HILL VALLEY - PHASE 2B

CITY PROJECT NO. 15860
CONTRACT NO. 9680

REVISION 1 - 04/29/26

REVISION 2 - 05/28/26

15860
 W-1

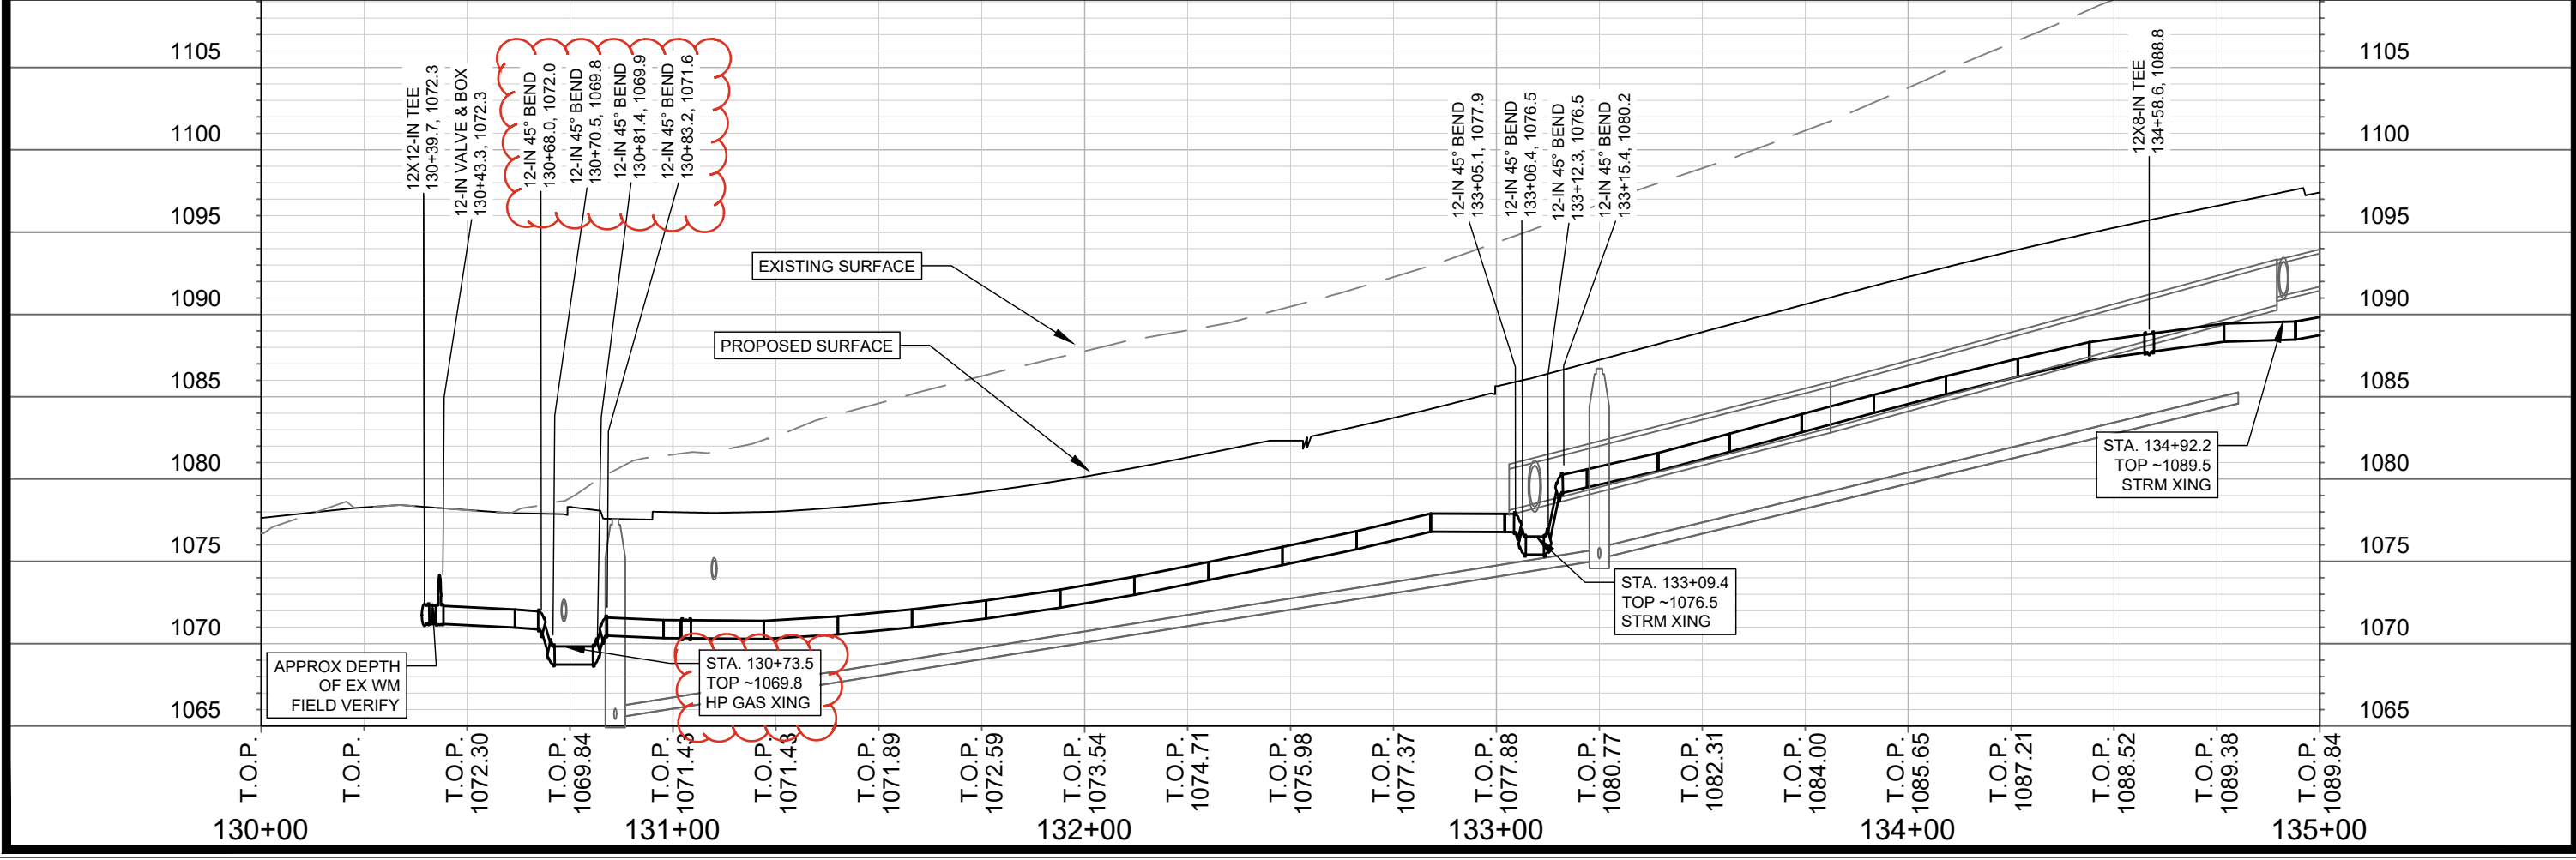
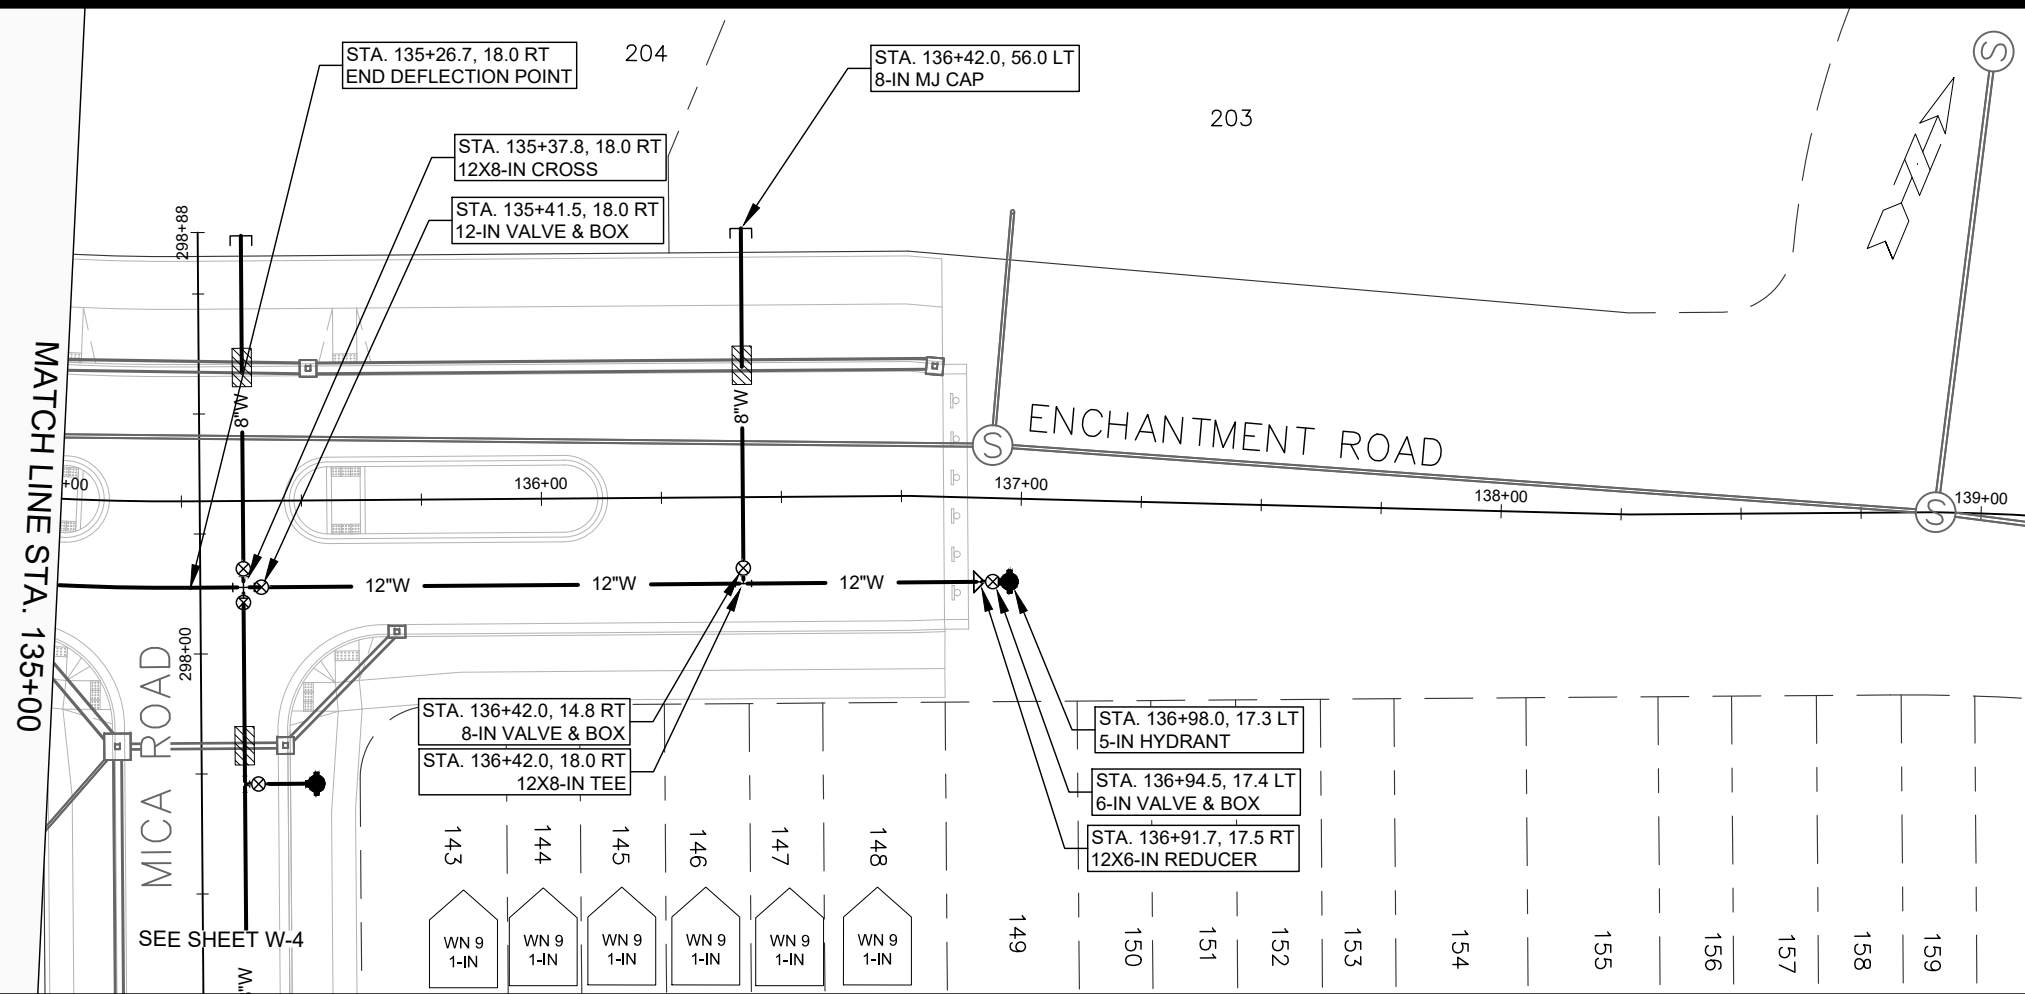
REVISION 2 5.28.26
REVISED CONNECTION TO EX. 12-IN
ADDED OFFSET AT HP GAS

15860
W-2

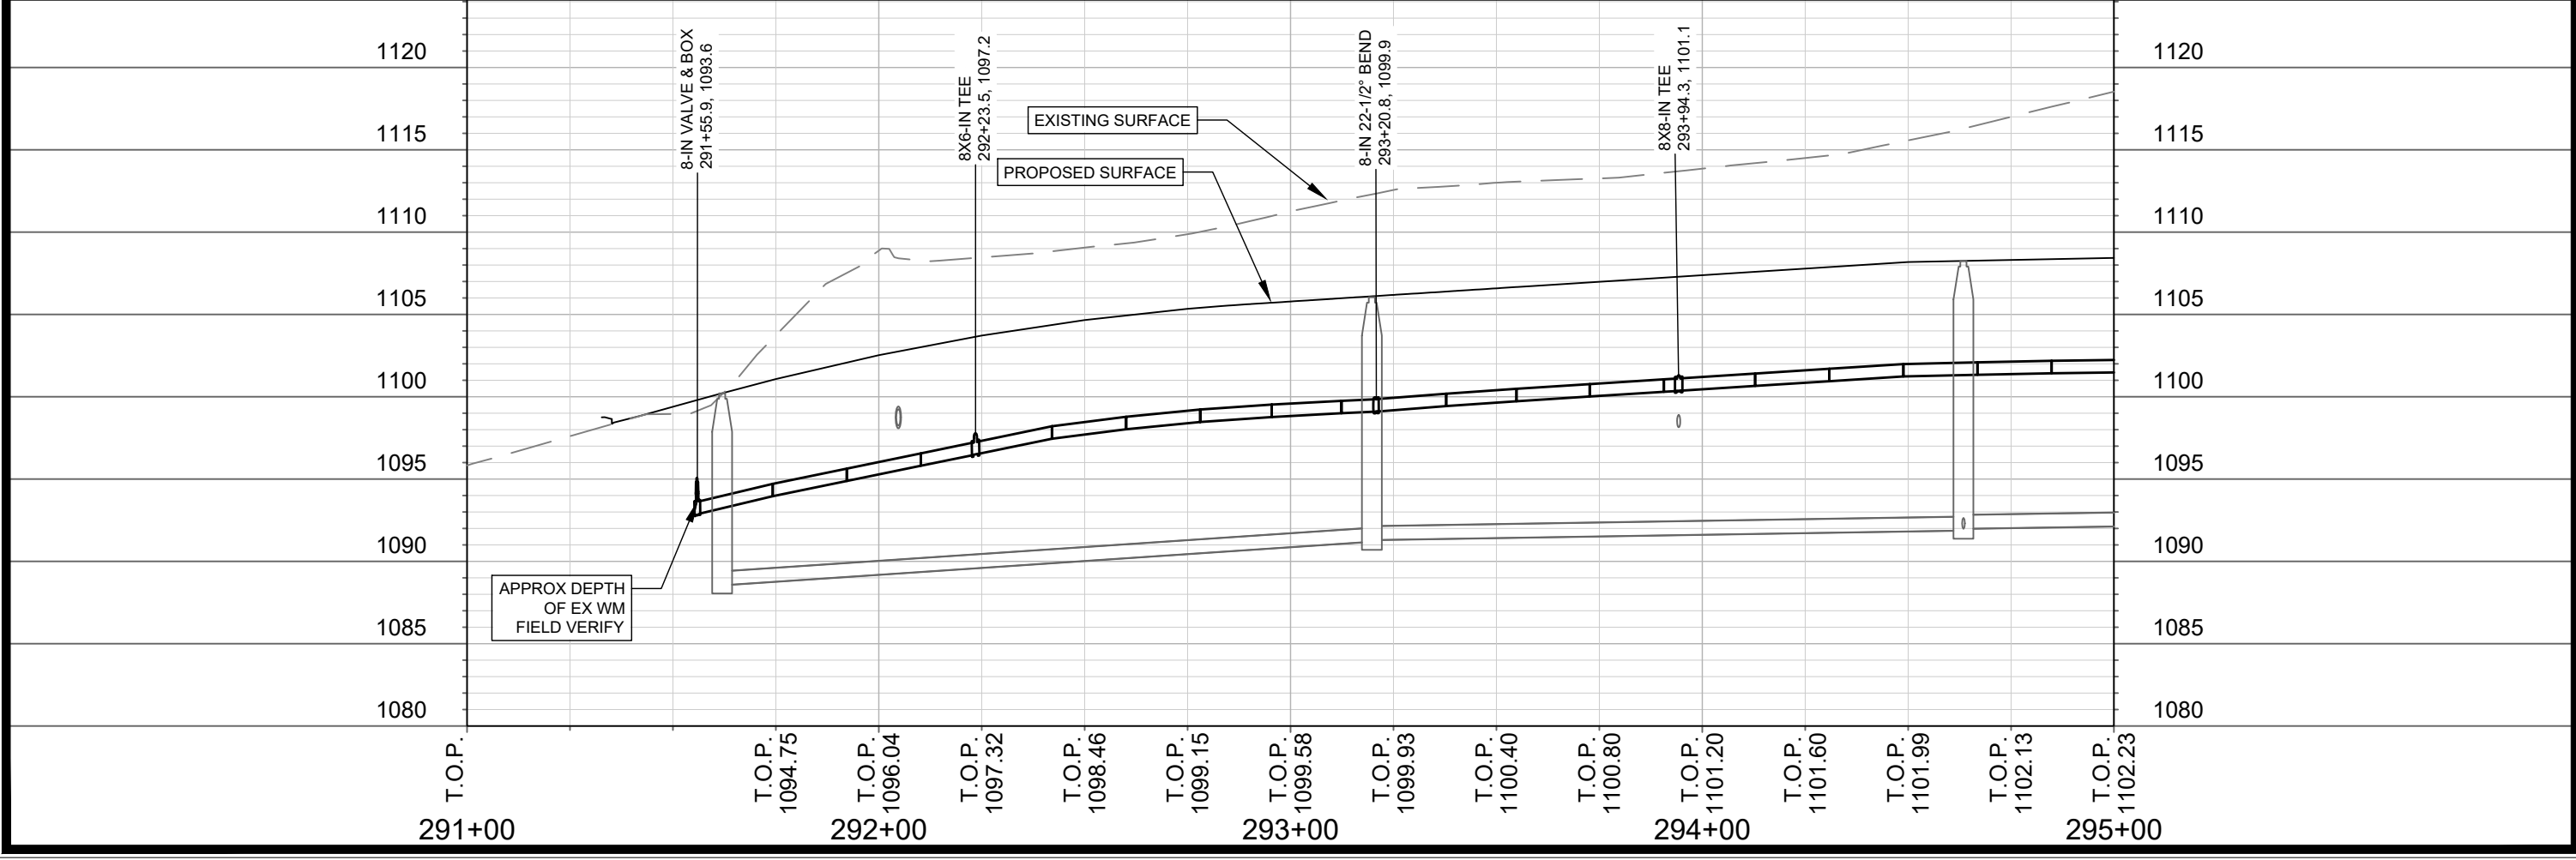
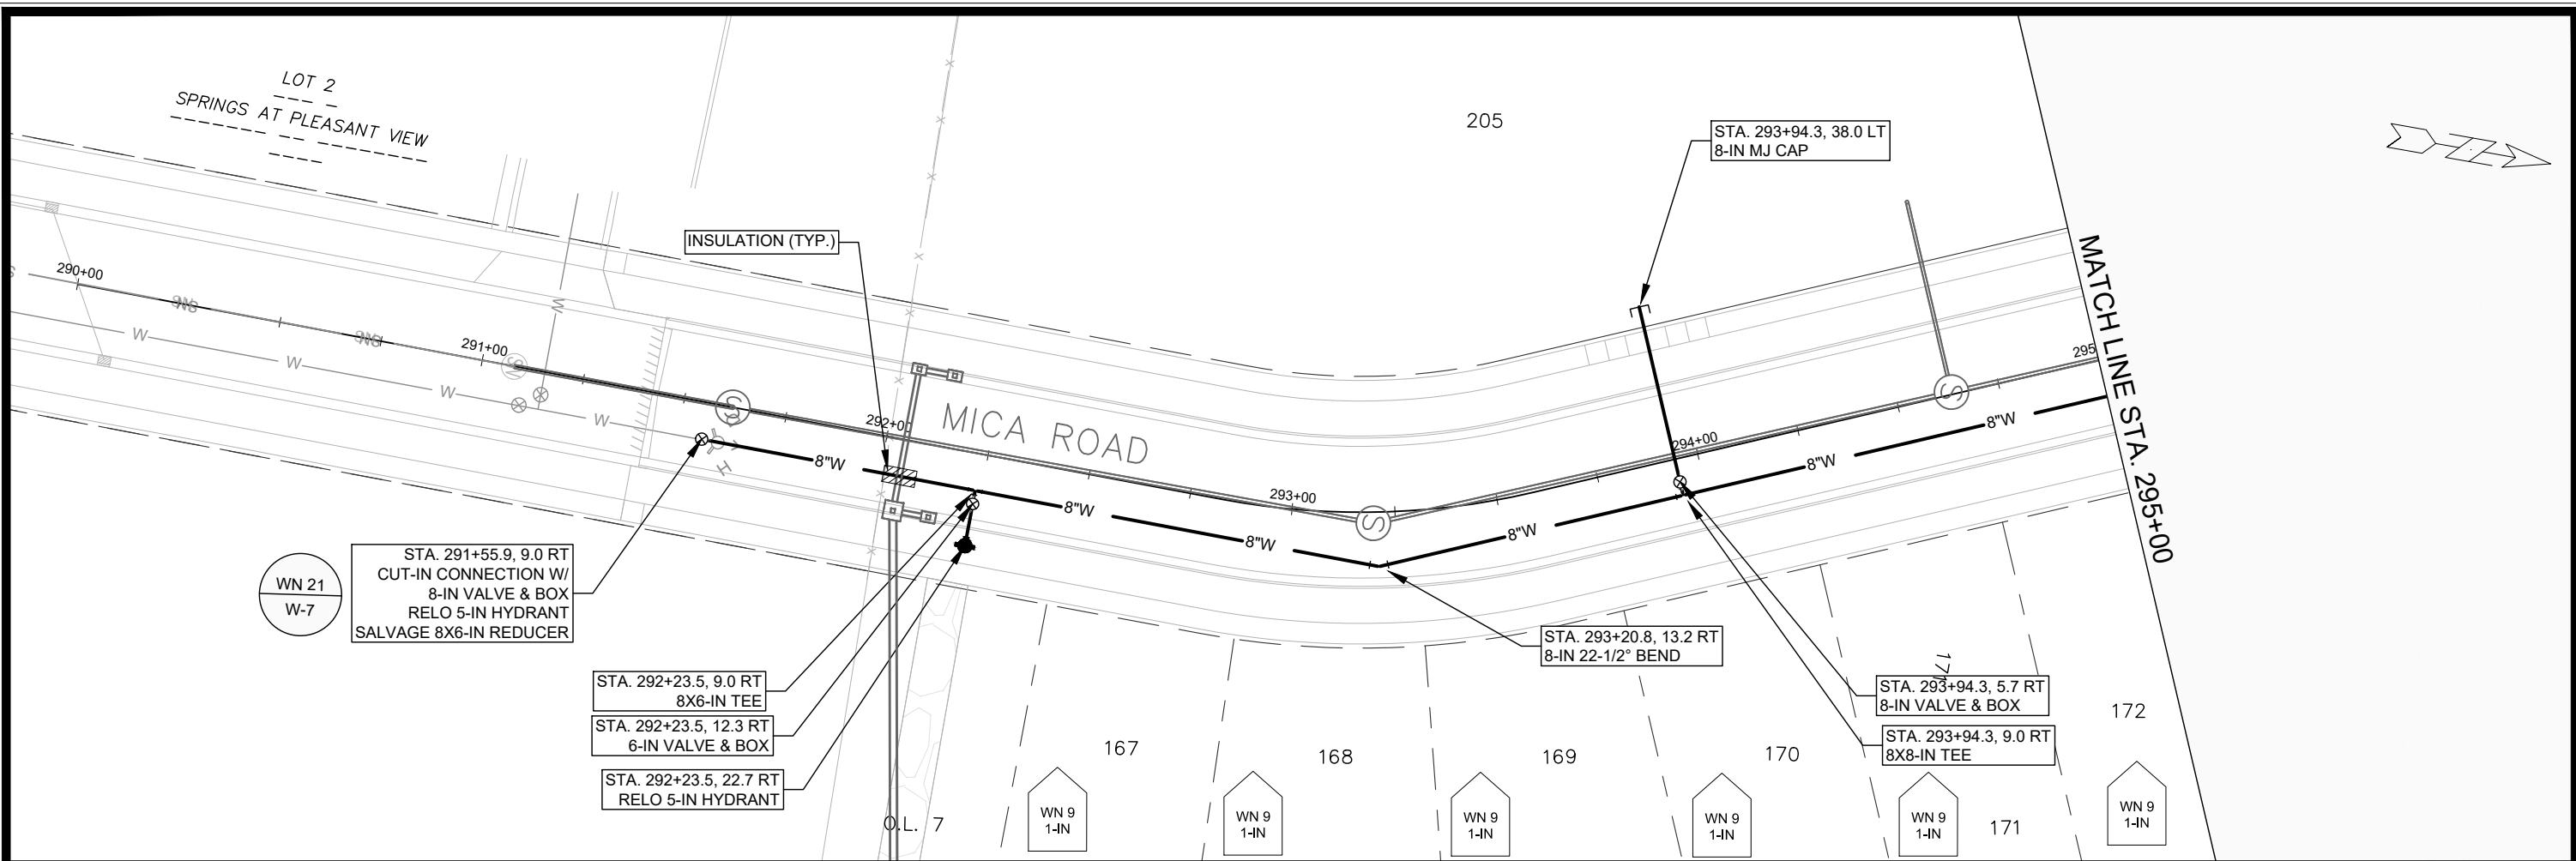
REVISION 2 5.28.26
REVISED STORM SEWER
